PRELIMINARY PLAN

MEADOW LAKE INDUSTRIAL PHASE 1

PRELIMINARY PLAN
SITE PLAN

SHEET SP 01

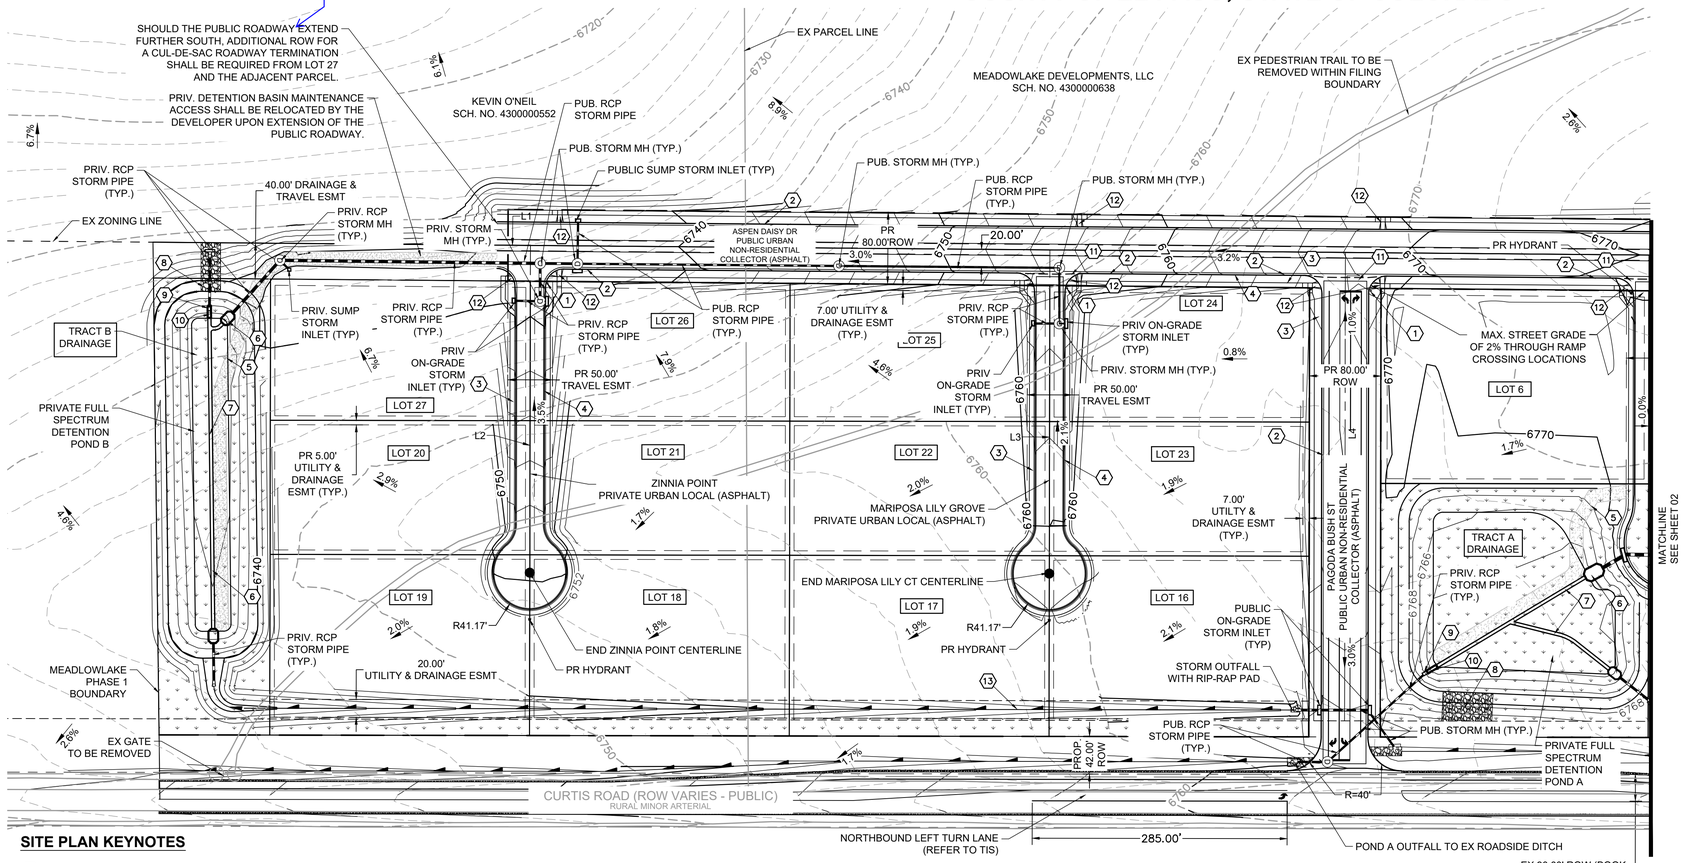
add the word not after roadway. The cul-de-sac is not needed if the roadway extends to the south

URBAN, LOCAL (PRIVATE)

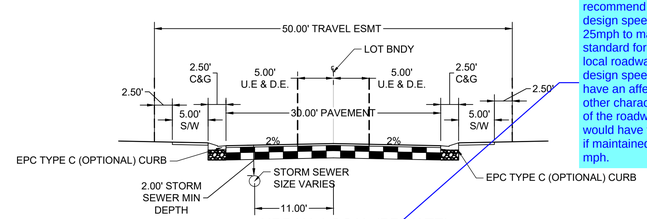
recommend revising design speed to 25mph to match EPC standard for urban local roadway. The design speed can have an affect on other characteristics of the roadway that would have to be met if maintained at 30 mph.

CURTIS ROAD - MODIFIED RURAL MINOR ARTERIAL - INTERIM FUTURE (PUBLIC)

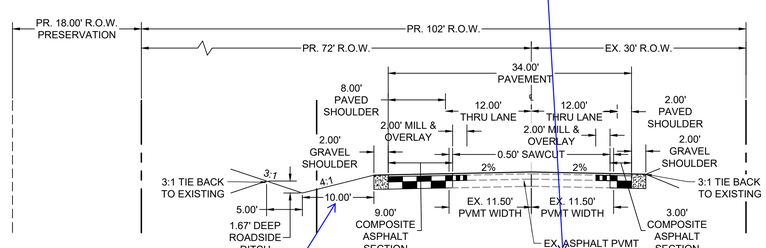
also provide cross section detail with turn lane improvements at Pagoda Bush St

URBAN NON-RESIDENTIAL COLLECTOR (PUBLIC)

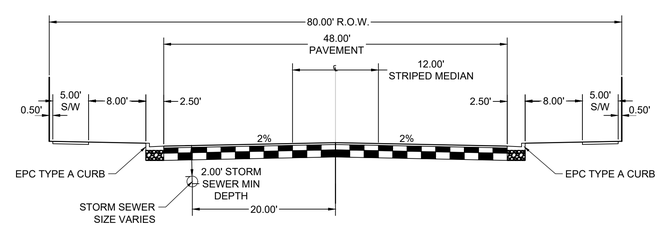
revise to 14' per County standard detail for rural minor arterial and to match Saddlehorn

CURTIS ROAD - MODIFIED RURAL MINOR ARTERIAL - INTERIM FUTURE (PUBLIC)

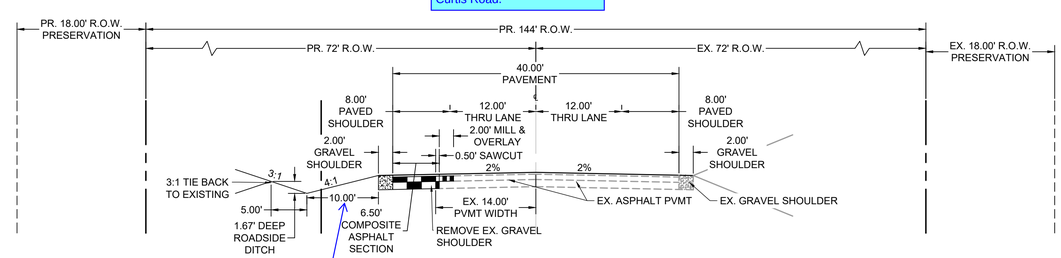
please submit a deviation request as indicated in the previous review comment for the modified cross section of Curtis Road.

14' per standard cross section
